# City of Richmond

## Report to Development Permit Panel

**File:** DP 23-031545

**Re:** **Application by Carson Lei for a Development Permit at 8680 Alexandra Road**

**SITE PLAN & STATISTICS**

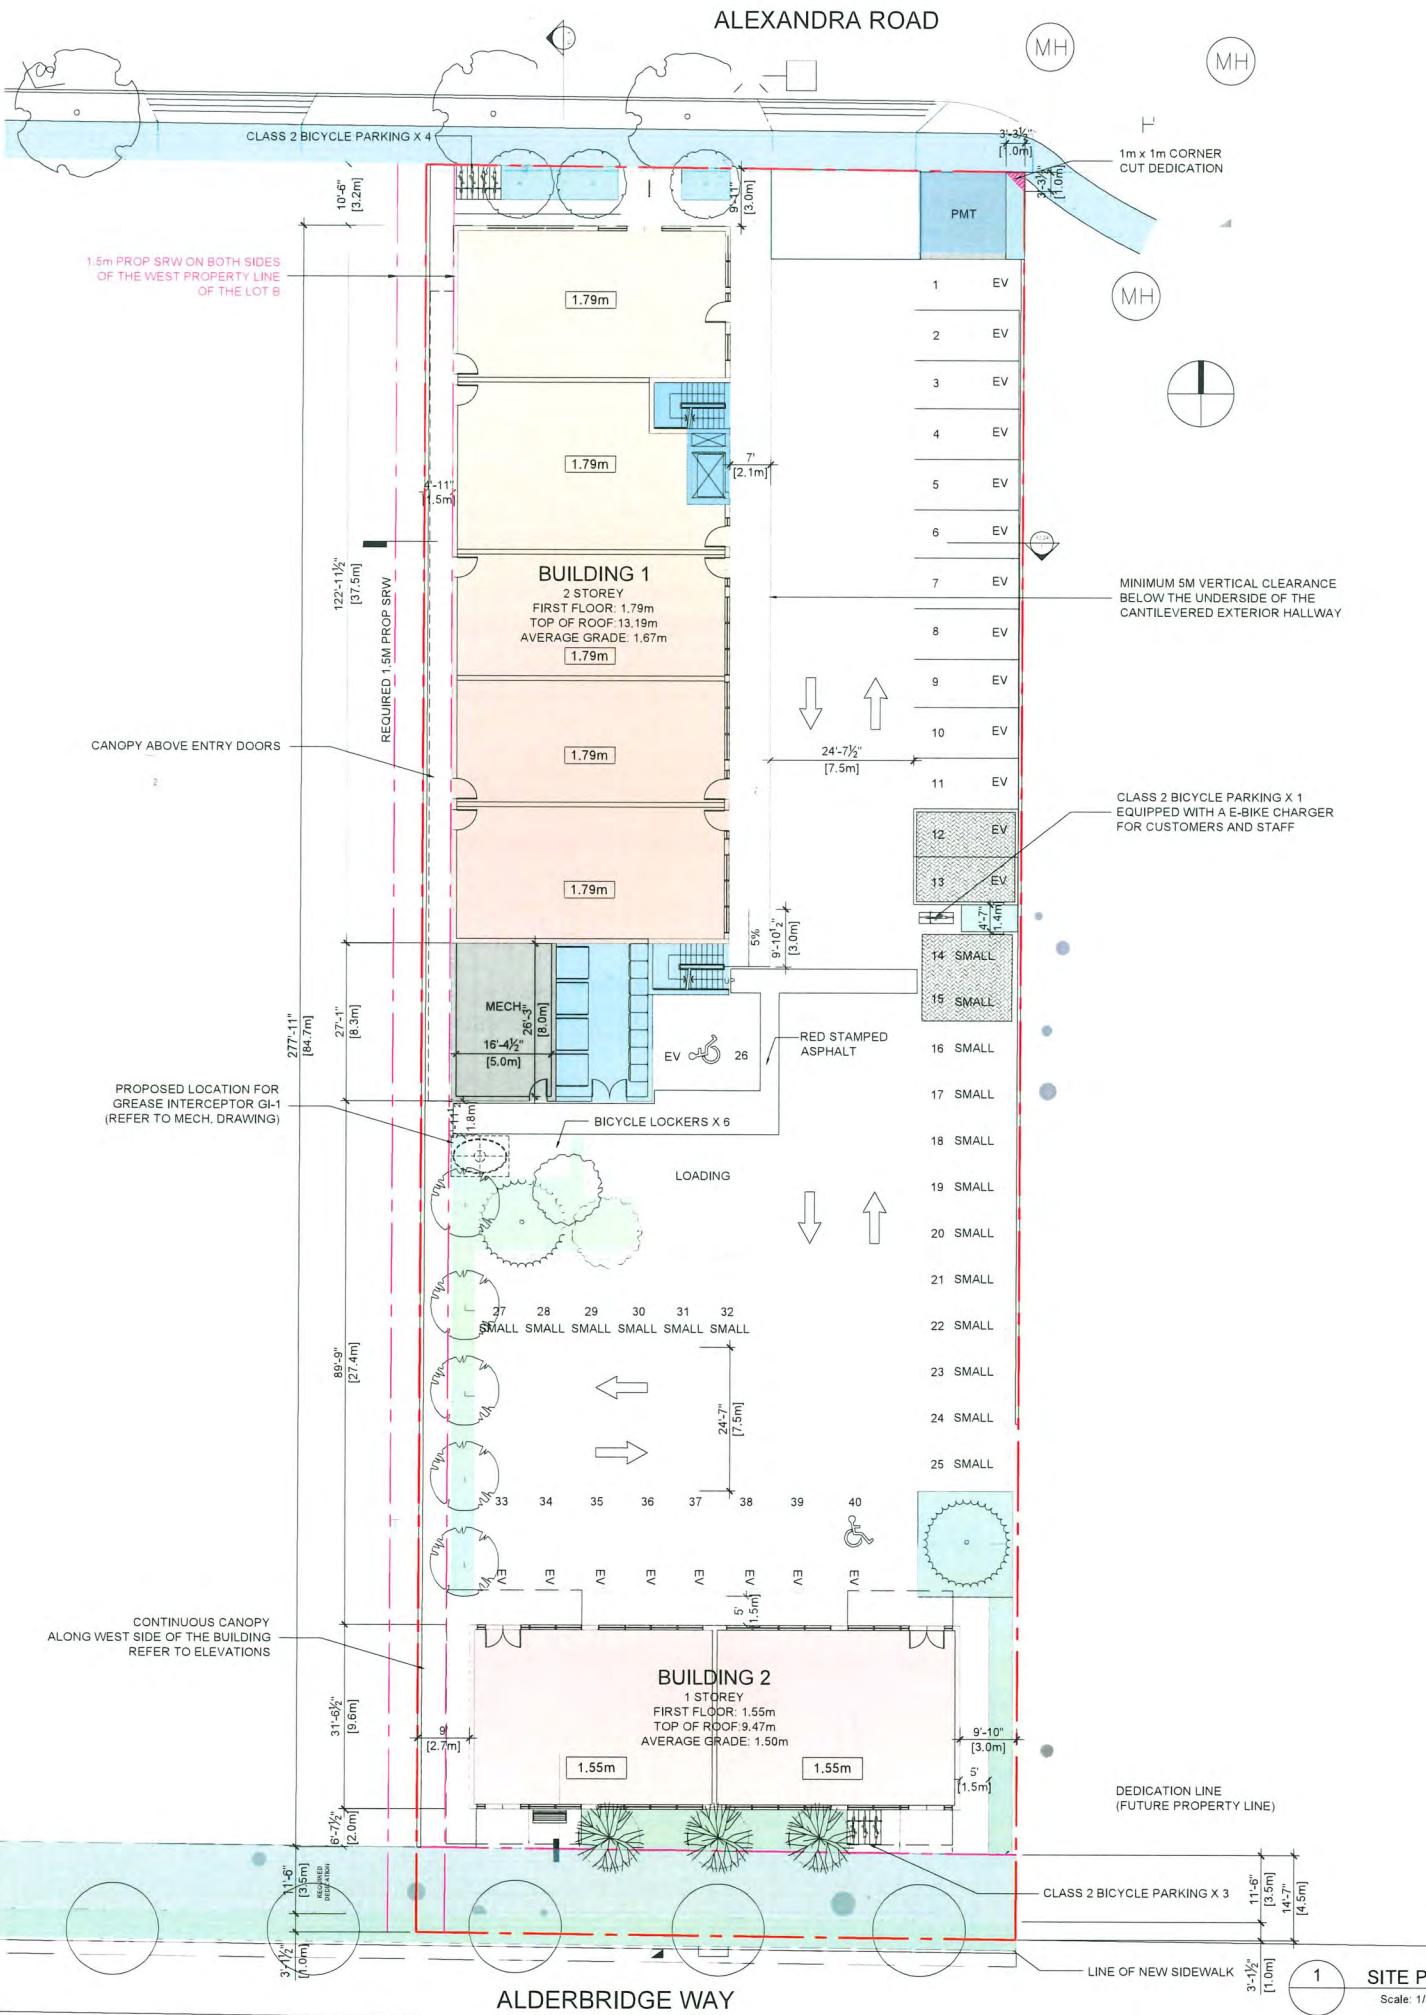
- considering identifying a location for grease traps to avoid grease coming from on-site restaurant operations going into the surface parking area; ***An underground grease interceptor location has been identified on the site plan. Future grease interceptors for restaurant kitchen fixtures will be contained within each unit.***
